REVIEWER 1

Hannaford et al. use a large sample of stream gauges in the UK to assess whether hydrological drought properties and low flows have changed in recent decades as well as at longer time scales. They place the results of their analyses in the context of climatic and water/land use changes and suggest that evidence for worsening drought is minimal, especially amongst many confounding influences from human impacts. I commend the authors for the work they have presented here, but believe that substantial edits are required to clarify results as well as to more fully address the influence of human water and land use on drought properties and low flows. I believe that these edits will lead to a paper that will be of interest to the broad readership of HESS.

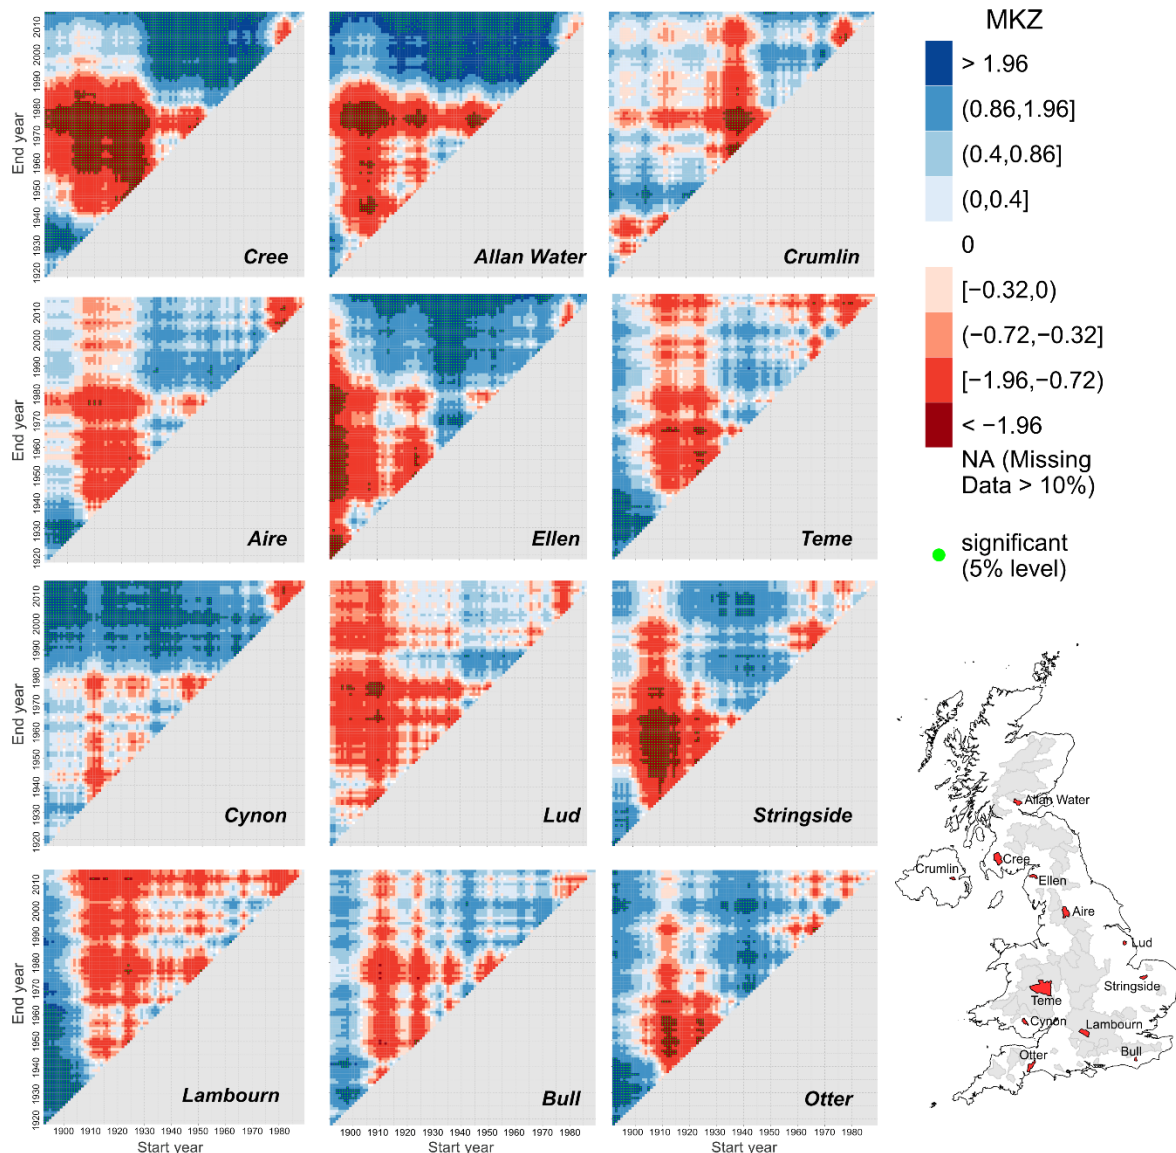
- Figure 4 legend symbol up down is opposite of what is shown on the maps for intensity and deficit.

Color scale for figure 6 is the reverse of intuition or the statistic seems reversed. Prior trend plots showed drought properties becoming longer and more intense through time in the south and shorter and less intense in the north.

>>> Thanks, agreed, we changed the colour scheme and symbology to reflect consistency with previous figures (red/upward arrow = worsening, etc). The figure below is the revised version with the correct legend. Note for max. intensity and deficit, positive trends mean decreasing drought severity whereas for duration, positive trends mean increasing severity.

>> the colours are correct. we will amend in the legend to emphasize again that positive trends (blue) indicate amelioration of drought and negative trends (red) indicate increasing severity. The question about the south is an interesting one, partly reflecting the fact there are very few catchments in the southeast, only the Lambourn, in the set used by Barker et al. 2019. For balance, we could add three more sites to give more in this area and a better distribution overall. The figure below shows multi-temporal trends re-calculated using SSI-12 for nine sites, including three new sites in East Anglia (Stringside), Kent (Bull) and southwest England (Otter), for example (we will review in the revised version).

Figure S2: Heatmap of SSI-3 for LFBN catchments (arranged roughly from north to south on the y-axis with one row per catchment and regions marked for clarity) from 1891 to 2015.

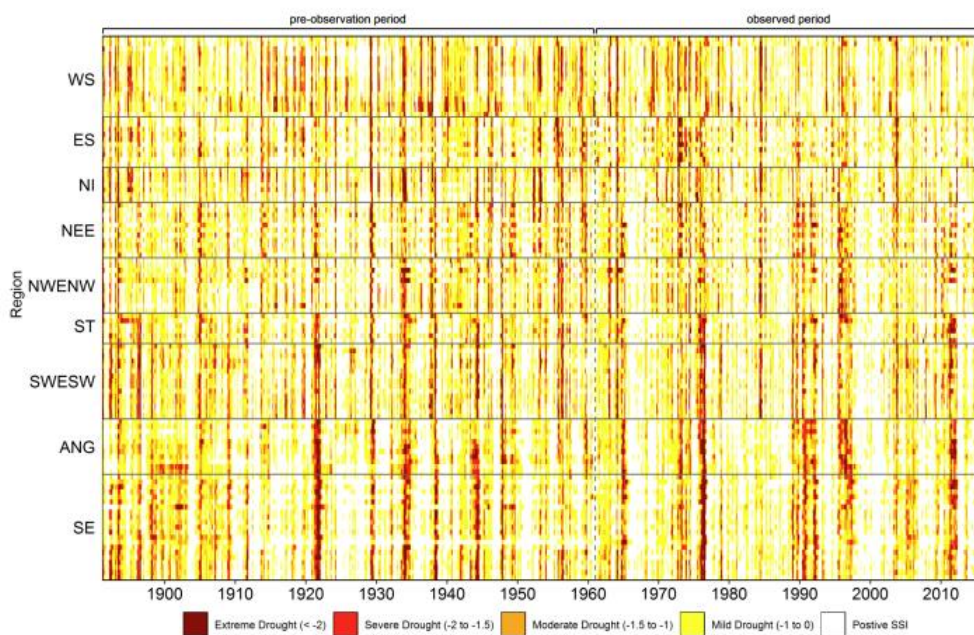
- There is inconsistency in the presentation of result, especially for Figure 5. The authors used SSI-3 in Figure 4, SSI-12 in Figure 5, and then return to SSI-3 in Figures 6 and 7. If possible, I suggest to replace SSI-12 in Figure 5 with SSI-3, as the author of Figure 5 is also a co-author of this paper.

>>> This is a good point, and such a figure exists (in SI of Barker et al. 2019, below). Nevertheless, SSS12 is a more useful descriptor of the main historical droughts, especially in the flashier north of the country. I propose we keep Fig 5 as SSI12 and change Fig 6 to SSI12 but retain the alternatives as a new SI in this paper.
